CERTIFICATE OF APPROPRIATENESS PLACARD

324 E DAVIE STREET

154-15-MW

Proposed Change to the driveway at 324 E Davie Street

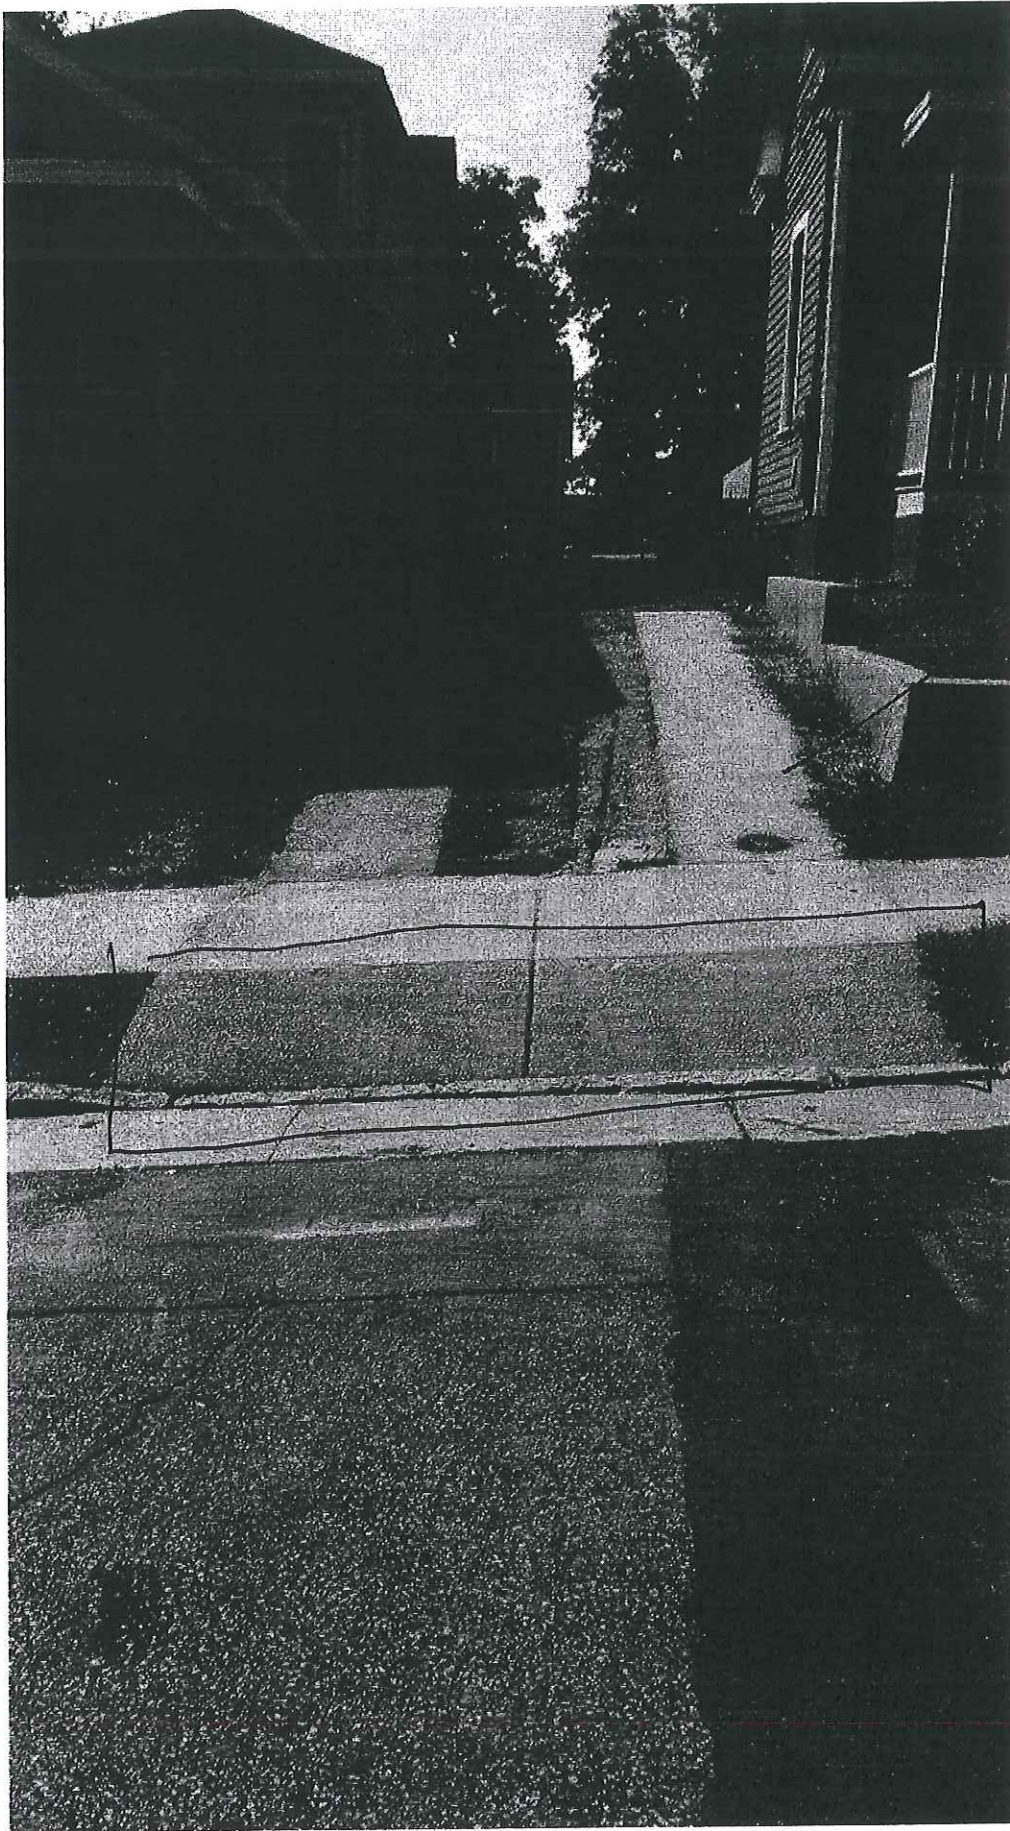
To change the grade ~~from the point of entry at the street to the existing strips~~ requires changing the grade of the city sidewalk that runs across the driveway.

> re Moved
per 10/23
email,

Staff site visit 10/20/15 confirmed change to
apron only. Sidewalk not changing. TGT

~~→ this will not
be changed.~~

~~this section is too
steep. cars & trucks bottom
out when entering & exiting
Even going extremely slow
& entering at an angle~~

~~The driveway will not be
altered in appearance or
style. We simply want
the grade to be correct
in order for cars to
use the driveway without
damaging the vehicles~~

Amendment
10/20/15
TGT

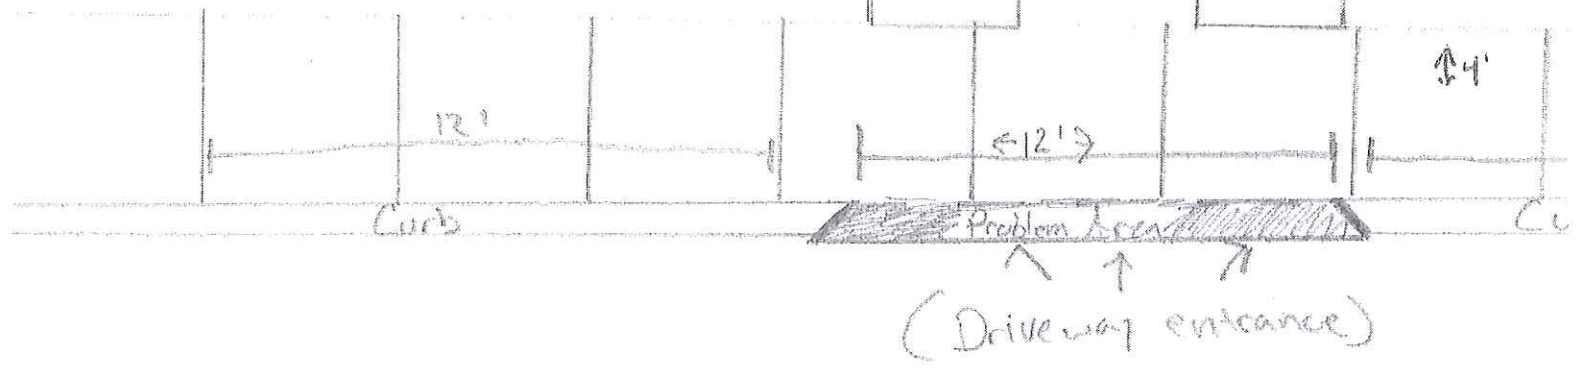
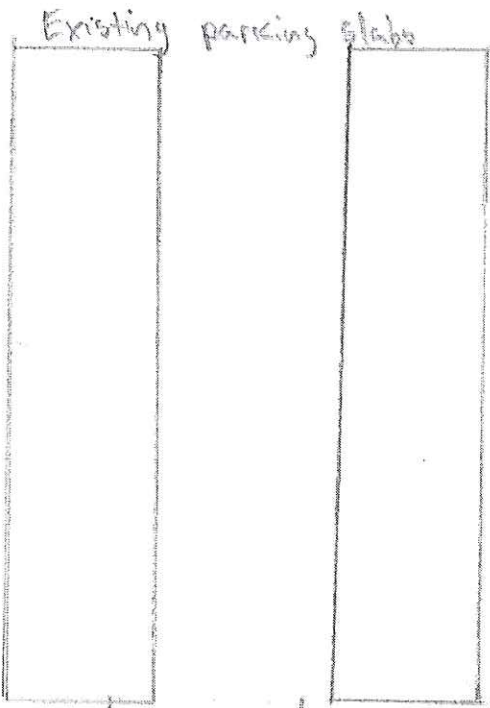
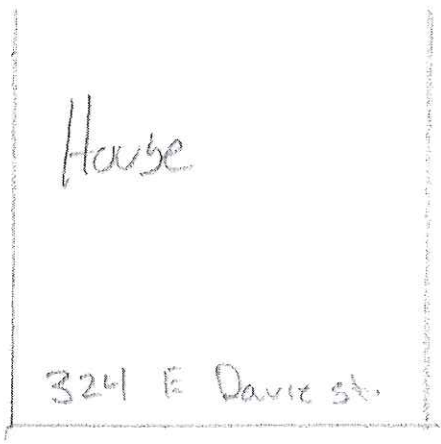
Remove 36' of existing concrete sidewalk in front of property. Remove existing driveway apron. No curbing will be disturbed.

Re slope new concrete sidewalks 30% in grade from grass to street to reduce slope of apron. Currently apron is approximately 50% grade and makes it impossible to enter driveway with most vehicles.

~~New slope of sidewalk will divert water run off to street gutter from both sides of driveway and allow apron to be under 30% grade to allow entry to driveway.~~

reduce slope

granite to be raised to apron surface

apron to extend length

As I explained to Jason on the phone yesterday, the drawings and description do not describe what will actually be happening.

As I understand it, the existing apron will be removed and replaced with a longer one of lesser slope. The additional length will go into the parking area of the street and not alter the slope of the sidewalk. The existing granite will then be raised up to the level of the apron and tie into the adjacent curbing.

The way you understand is correct, per Andy that is how it will be completed.
